June 21, 2013

**RE: MAHONING COUNTY, CANFIELD TOWNSHIP, SUMMER WIND PRIVATE ESTATES
(PARRY FARMS), NPDES PERMIT NO. 3GC04939*AG, OHIO EPA PERMIT NO. OH000003
CONSTRUCTION STORM WATER INSPECTION, NOTICE OF VIOLATION**

Figure 9 – Yard inlet protection was failing throughout Site II.

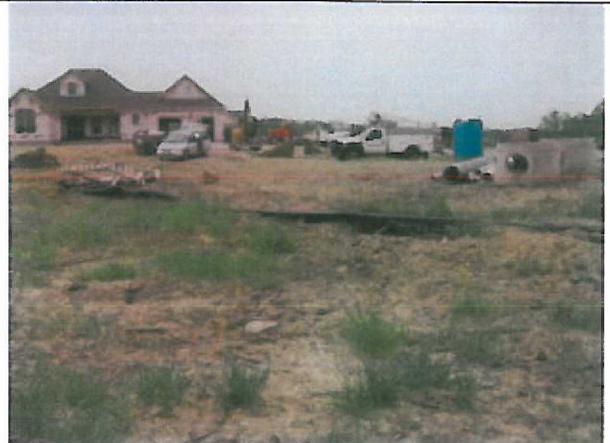
- Silt fence and yard inlet protection was failing throughout Site II and requires maintenance (Figures 9 to 10). Within three days of receiving this NOV, all inlet protection and silt fence must be repaired and/or replaced, if applicable. **The failure to provide functional sediment BMPs during the course of earth disturbing activities constitutes violations of ORC 6111.07 and Part III.G.2.d.i. of the General Storm Water Permit.**
